## **215 Liquid Handler Up-Grade Manual**

For Up-Grade to Run with XWINNMR Vers. 3.1

Manual # H9771

## H9770 BEST –NMR Up-Grade Kit to XWINNMR 3.1

## New Capillary Setup running under XWINNMR 3.1

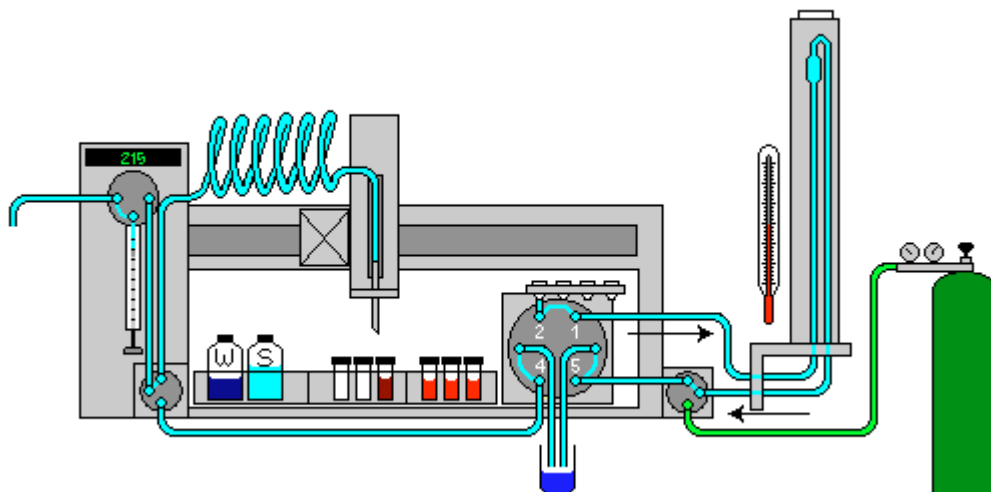
The new setup will be introduced with a new and more flexible BEST-NMR software package. The direct control of the Gilson will be used and therefore no **Gilson 606M interface** and no **keypad** with the **ABIMED software** will be needed. Also one 819 valve will be enough to offer all actions that are currently implemented. This change was possible by re-engineering the flow path. This new software will be introduced with the Release to XWINNMR 3.1

## 7BEST – NMR Gas Valve Switch (modified Recover Module)

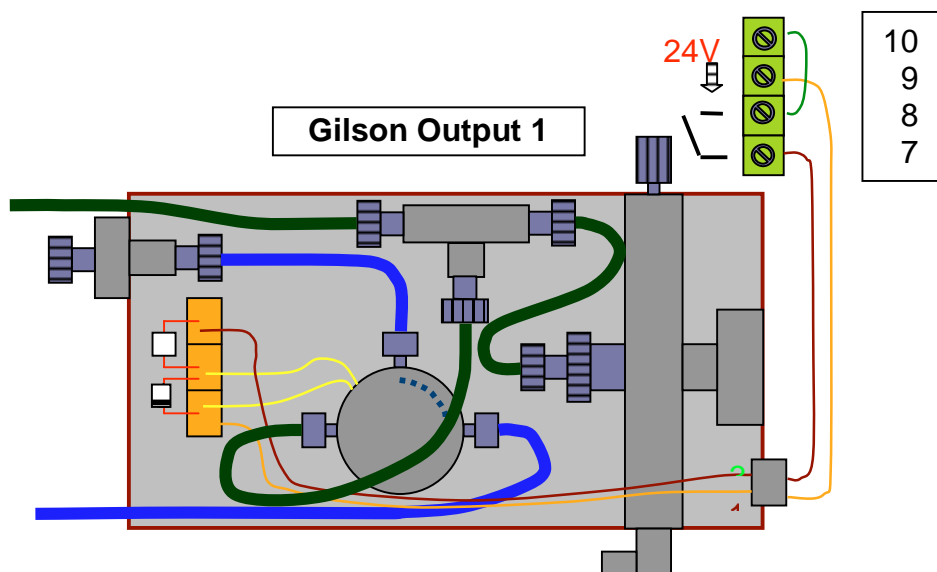
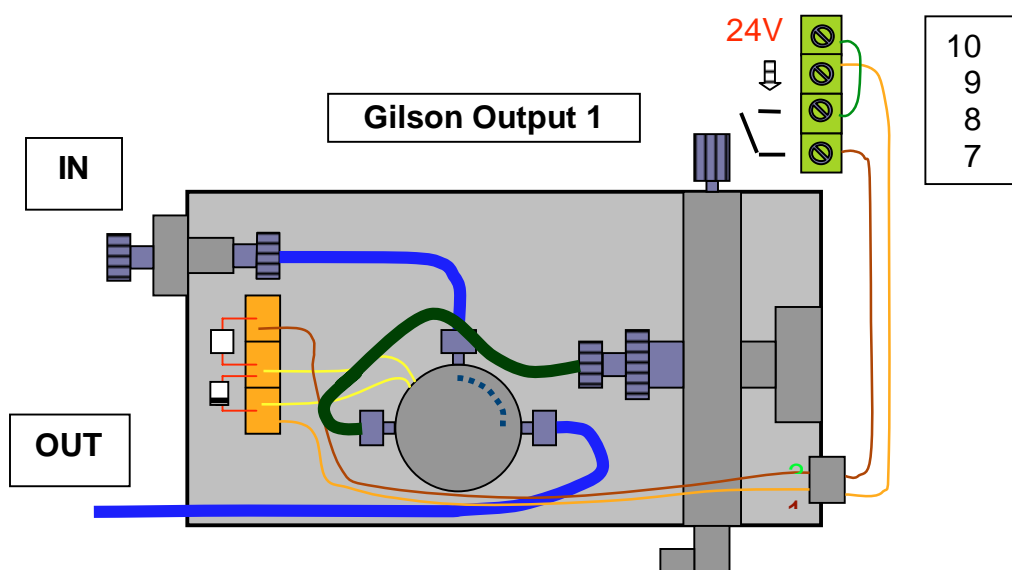
- The current “Recover Module” once modified will work like the future “Gas Valve Switch”.

You have three options for the modification of the current “Recover Module”

Either you just plug the outer PEEK capillary (connector and plug out of the Up-Grade Kit) or you are going to open the “Recover Module” and remove the T-piece with the Gas Out capillary. The Peek capillary coming from the Pressure regulator will then be connected directly to the switching valve. (see drawing) Removing the T-piece could be sometimes a bit tricky, therefore one also could think about using the PEEK gas line like described in the next chapter.

As an alternative, you can mount the out coming PEEK gas capillary to an additional closed injection port (Bruker #HZ06807) which will be mounted to one of the three port holes on the Gilson injection port plate. With this you can provide inert gas gaps for you application.
